King George 5th Playing Field – Planning Ref 25/0197/FUL

Devon Tree Services, as consultee for Exeter City Council

The revised AIA report (Rev B) with updated TPP is **attached** responding to points raised by Devon Tree Services as consultee.

Existing Car Park Plan (extract from topographic survey)

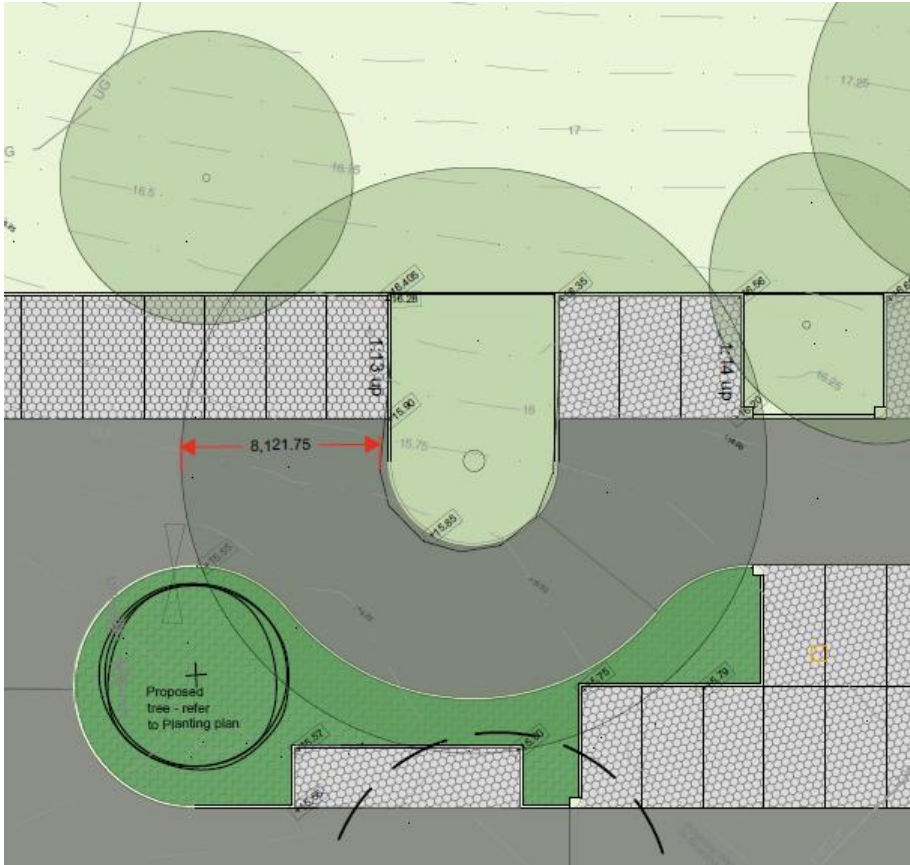
1. **Consultee comment** - T16, a mature Beech tree, which are particularly sensitive to development-related disturbance, especially root disruption and changes in soil conditions. No detailed specifications or construction methodologies have been provided to support its protection and as such, the works are likely to result in short-term decline and potential long-term death of the tree”

Doug Pratt Tree Consultancy response - The level of extension into the RPA of beech tree 16 is marginal in nature and is fully compliant with BS 5837:2012: Trees in Relation to Design, Demolition and Construction – Recommendations – 7.4.2.3 New permanent hard surfacing should not exceed 20% of any existing unsurfaced ground within the RPA. As discussed, there is capacity to modify the parking surfacing in this area utilising geogrid products and finishing with porous surfacing, which can be combined with specific methodology and arboricultural monitoring, which can be a condition of planning consent. Additionally, on the existing plan, you can see the existing impervious tarmac extends about 7.5m, to the west of the soft landscaping around the tree. On the proposed plan the extra tarmac affecting the tree is only a further 0.74m beyond this to the west and this is easily offset but the geo grid (drained) parking bays either side of the tree. The area of the geo grid is around 70 sq metres under the tree canopy. Given this I would say that the proposed arrangement is a significant improvement over the existing arrangement and can benefit the beech tree in the long term.
